Request for Class II Permissive Change

FCC ID: IBAMF8235

Please be notified that we, the undersigned, Creative Labs Inc declare the following changes to enhance product performance.

MS2220A (I/O board)

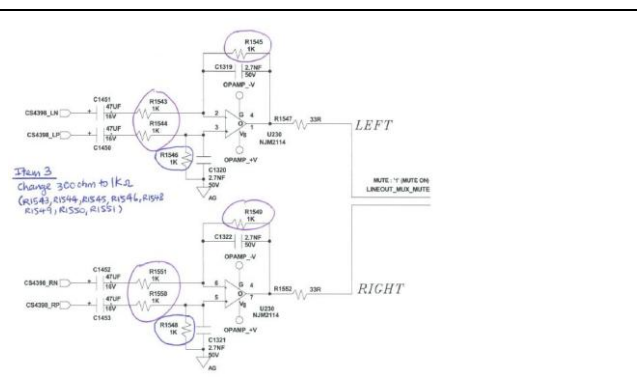
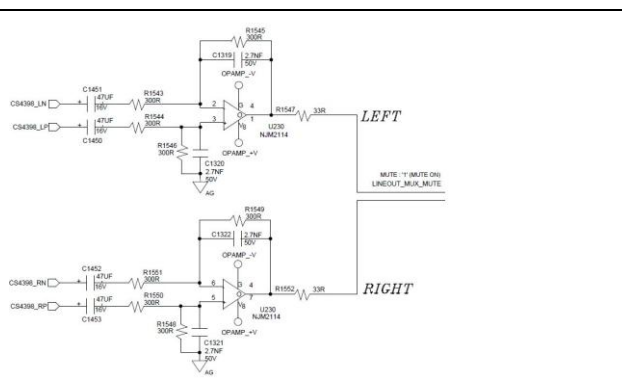
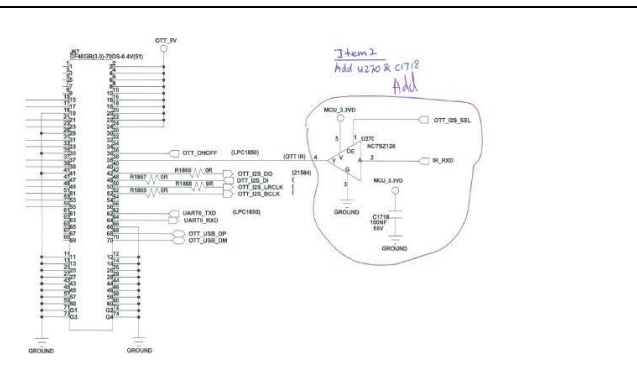
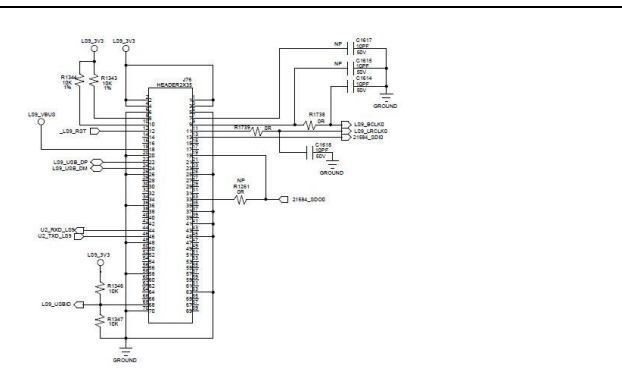
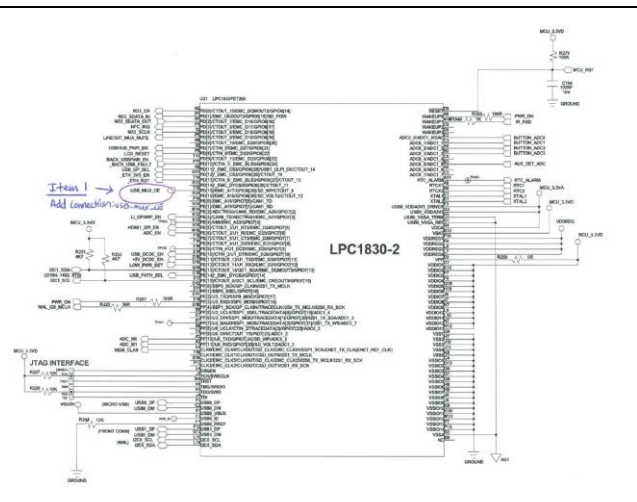
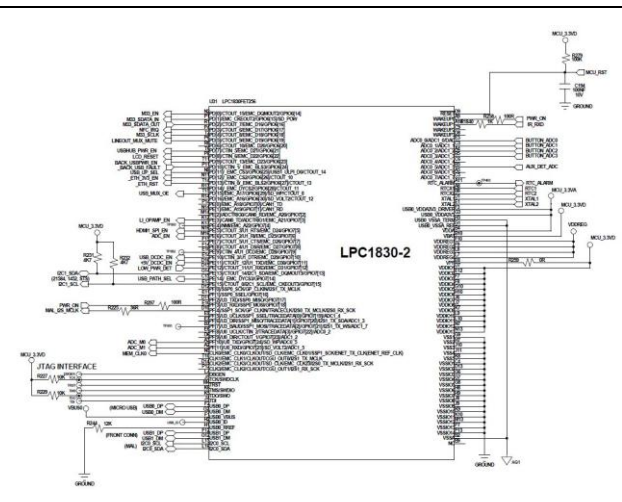
MS2220A (I/O board)		
Reason for change	Before	After
01) USB Bus switch control		a) Add connection – USB_MUX_OE
02) Resolve unable to wake using IR issue	a) --	a) ADD BUFFER IC U270 & C1718 FOR IR SIGNAL

03) Improve Audio Performance	a) R1551, R1550, R1548, R1549, R1543, R1544, R1545, R1546 (300ohm)	a) R1551, R1550, R1548, R1549, R1543, R1544, R1545, R1546 (1Kohm)

04) Improve low power logic detection	a) Q94 (FDV301)	a) Q94 (PMBT3904)
05) Audio mapping	a) – b) --	a) U71 (I/O ports remap) b) HDMI 1 (Add HDMI_MCLK to GRIFFIN) (Optional)

06) Improve HDMI trace impedance	a) – b) – c) – d) --	Add series resistor at HDMI RX port a) R1886, R1885, R1890, R1892, R1887, R1888, R1889, R1891, b) R1625, R1624, R1629, R1623, R1626, R1627, R1628, R1632, c) R1894, R1896, R1897, R1899, R1895, R1896, R1897, R1899, d) R1902, R1901, R1906, R1908, R1903, R1904, R1905, R1907

07) Improve CEC signal	a) R1882 (10K) b) Diode D67, D80, D81, D82, D83, D85	a) R1882 (27K) b) Remove diode D67, D80, D81, D82, D83, D85
08) Improve Audio performance	a) --	a) LINE-IN: Add Ferrite (L230) at CONN to Ground

09) Recycle GPIO pin, improve THD	a) --	a) SUBW: Change CONTROL SIGNAL to LI_OMP_EN b) Add Mute circuit
10) Improve Audio performance	LINE-IN: C1576, C1577, C1578, C1579 a) With polarity b) 100uF	LINE-IN: C1576, C1577, C1578, C1579 a) Change E-cap to non-polarity type b) 10uF

11) CHANGE reduce OPAMP GAIN		Change value:

Improve THD & output matching	a) R1395 (1K), b) R1165 (1K), c) R1397 (1K), d) R1396 (1K)	a) R1395 (11K), b) R1165 (15K), c) R1397 (15K), d) R1396 (11K)

12) EMI - patched at 4P board during the test		a) INT MIC: Add 27pF between AG and GROUND
13) Correction	a) J26	a) J26: Swap Mic L R signal
14) Help discharge USB HUB_3V3 faster	a) --	a) Add Resistor (R1916) LOAD TO USB HUB_3V3 POWER

15) Improve IC mcore IC 1V2 supply voltage	a) R1383 (3K)	Change value a) R1383 (2K7)
16) To meet DDC pull high spec	a) R1861, R1862, R1597, R1598 (47K)	Change value a) R1861, R1862, R1597, R1598 (2K)

17) Reduce mic noise	a) R1883 (0ohms)	a) Remove R1883 (0ohms)
18) Add location	a) --	a) Add J79 location (not mounted)
19) Change control signal	a) U265	a) U265 (Change control signal)

20) Set EEPROM to 8-bit mode for LAN7500	a) U217	a) U217 (Pull pin6 to low)
21) Remove STS Audio Noise	a) --	a) Add decoupling caps (C1723 100nF 10V) in between STS_VDD and Ground)

22) Connection correction	a) --	a) U252 (Remove R657, and connect pin 52 to pin 10)
23) Reduce pop sound	a) C1323 & C1324 (1800pF 50V)	a) C1323 & C1324 (Change to resistor 10K)

24) Connection correction	a) U269	a) U269 (Add 10K resistor in between pin12 and ground)

MS2220B (Power Supply board)

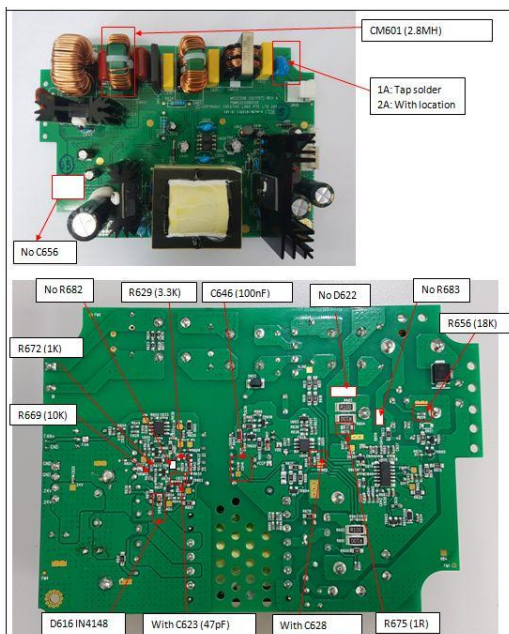
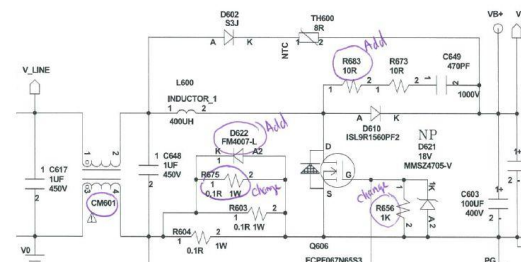
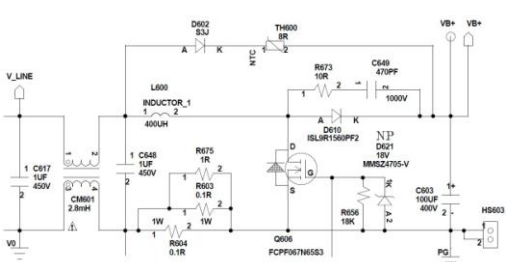
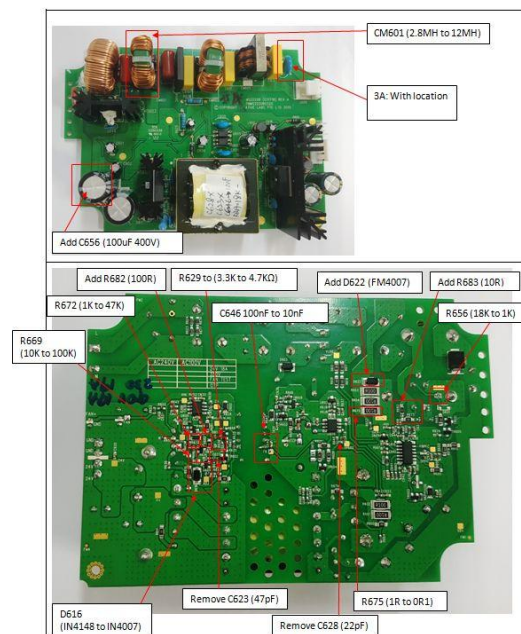
MS2220B (Power supply board)		
Reason for change	Before	After
01) Improve power supply performance	a) -- b) --	a) Add C656 (100uF 400V) b) Add Diode D622 (FM4007)
02) Resolve hissing noise	a) C623 (47pF)	a) Remove C623 (47pF)
03) Improve power supply performance	a) D616 (4148) b) R672 (1K) c) R669 (10K) d) R675 (1R) e) R629 (3K3) f) CM601 (2.8MH) g) C646 (100nF)	Change value a) D616 (4007) b) R672 (47K) c) R669 (100K) d) R675 (0R1) e) R629 (4K7) f) CM601 (12.5MH) g) C646 (10nF)
04) Improve power supply performance	a) C628 (22pF)	a) Remove C628 (22pF)
05) To improve EMC performance	a) --	a) Add R683 (10R)
06) To regulate voltage at U609	a) --	a) Add R682 (100R)
07) To protect mosfet Q606	a) R656 (18K)	a) R656 (1K)

MS2220C (Amplifier board)

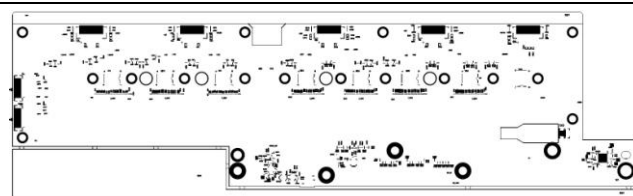
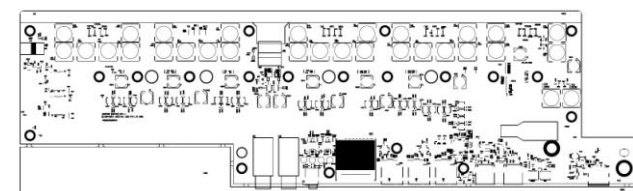
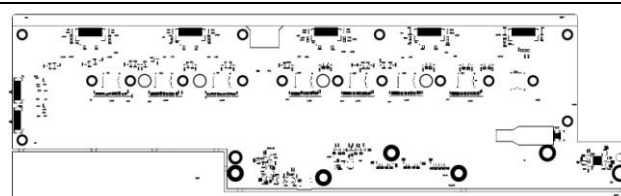
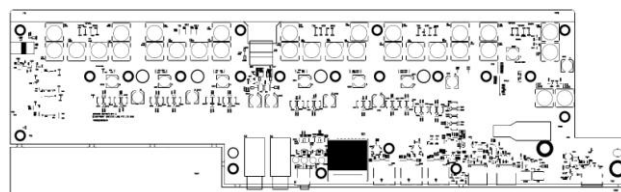
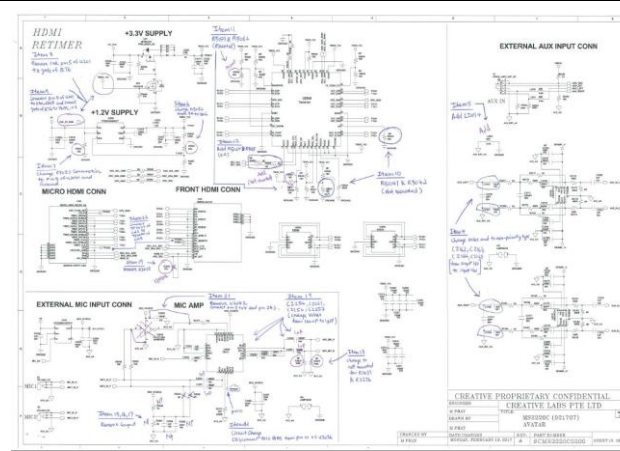
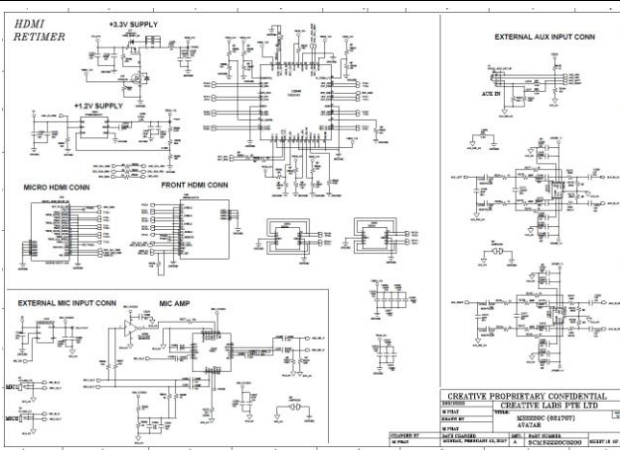
MS2220C (Amplifier board)		
Reason for change	Before	After
01) Control PCM1690_VCC5 power sequence together with PCM1690_VDD33 via DAC_ENB	a) Q70, R825	a) Remove Q70 (TRA0200030110) & R825 (REA01J4702J00) and link Q69's gate to DAC_ENB

02) Unmute audio DAC permanently	a) -- b) --	a) Remove both PCM1690A_AMUTEI control from U93 & U94, b) Add R5063 (REA01J1002J00) pull up to both pin18 of U93 & U94

03) To control the REST of the USB host controller	a) --	a) Add PCM1690_AMUTEI to control pin38 of U2010
04) Improve the audio performance of AUX- in	C2162, C2163, C2164, C2165 a) With polarity type b) 100uF	Change: C2162, C2163, C2164, C2165 to a) Non-polarity type b) 10uF

05) Connection correction	a) --	a) Link AUX_REF_AG with GROUND via L2054 (NDA073600L022)
06) Improve the power up sequence of TMDS_1V2	a) R5052 (3K)	a) R5052 (5K6)

07) Improve the power up sequence of TMDS_3V3	a) --	a) Change connection for R5053, connect between pin 5 of U2041 and Ground
08) Connection correction	a) --	a) Remove link pin 5 of U2041 and gate of Q76

09) Connection correction	a) --	a) Connect pin5 of U2041 to DAC_5V_ENB and connect gate of Q76 to TMDS_1V2
10) Change the HDMI re-timer configuration	a) R5041, R5042	a) Unmount REA01J1002J00 from R5041 & R5042

11) Remove I2C link	a) --	a) Mount REA01J1002J00 on R5059 & R5062
12) Add location	a) --	a) Add series resistor R5064 & R5065 location (Not mounted)
13) To improve MIC audio performance	a) R2039, R2276	a) Unmount REA01003J00 from R2039 & R2276

14) Add Front Mic HW detection for Mic amp	a) --	a) Disconnect Mic BIAS from pin 10 of U2036
15) Power decoupling for MIC	a) C2024 (1uF 10V)	a) C2024 (22uF 10V)

16) Add MIC Bias circuit	a) --	a) Add new MICbias from M33_VCOD33 with R5068 (REA01J1001F00) & R5069 (REA01J2001F00) as potential divider
17) Improve MIC signal performance	a) C2256,C2257,C2254,C2267,C2252 (100nF)	Change value a) C2256,C2257,C2254,C2267,C2252 (1uF)

18) HDMI retime hot plug detect fix	a) R2038 (1K5)	a) Remove R2038 (1K5)
